Proposal for a Supplement to the 01 series of amendments to UN Regulation No. 148 and to the 06, 07, 08 and 09 series of amendments to UN Regulation No. 48

Submitted by the expert from the International Automotive Lighting and Light-Signalling Expert Group \*

The text reproduced below was prepared by the expert from the International Automotive Lighting and Light-Signalling Expert Group (GTB) with the aim to introduce Direction Indicator projections. This revised proposal is based on document ECE/TRANS/WP.29/GRE/2024/21. The modifications to the existing text of the UN Regulation are marked in bold for new or strikethrough for deleted characters.

#### 6.27.5. Projection area

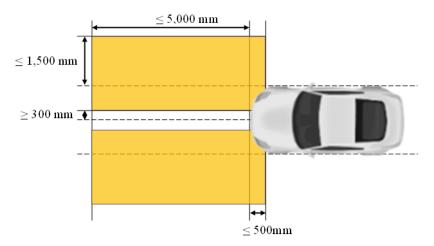
#### 6.27.5.1. Front direction indicator projection

The lateral distance from the outer edge of the projection with respect to the extreme outer edge of the vehicle shall not be more than 1,500 mm.

The longitudinal distance from the farthest edge of the projection shall not be more than 5,000 mm from the forward extreme outer edge of the vehicle and the rearward edge of the projection shall be not more than 500 mm rearward of the forward extreme outer edge of the vehicle.

The inner boundary of the projection area is limited by a minimum distance of 300 mm from the longitudinal centre line of the vehicle (see figure below).

### 6.27.5.2. Rear direction indicator projection

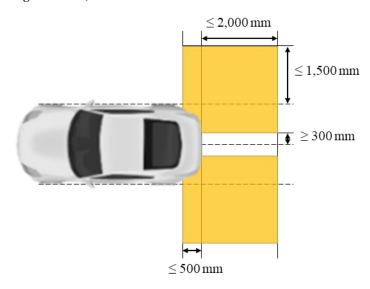
The lateral distance from the outer edge of the projection with respect to the extreme outer edge of the vehicle shall not be more than 1,500 mm.

The longitudinal distance from the rearmost edge of the projection shall not be more than 2,000 mm from the rearward extreme outer edge of the vehicle and the forward edge of the projection shall be not more than 500mm forward of the rearward extreme outer edge of the vehicle.

The inner boundary of the projection area is limited by a minimum distance of 300 mm from the longitudinal centre line of the vehicle (see figure below).

#### 6.28.5. Projection area

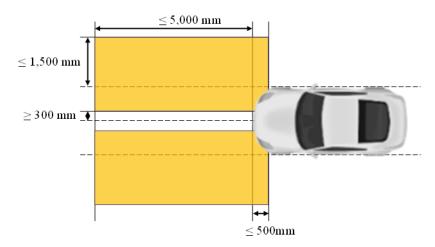
#### 6.28.5.1. Front direction indicator projection

The lateral distance from the outer edge of the projection with respect to the extreme outer edge of the vehicle shall not be more than 1,500 mm.

The longitudinal distance from the farthest edge of the projection shall not be more than 5,000 mm from the forward extreme outer edge of the vehicle and the rearward edge of the projection shall be not more than 500 mm rearward of the forward extreme outer edge of the vehicle.

The inner boundary of the projection area is limited by a minimum distance of 300 mm from the longitudinal centre line of the vehicle (see figure below).
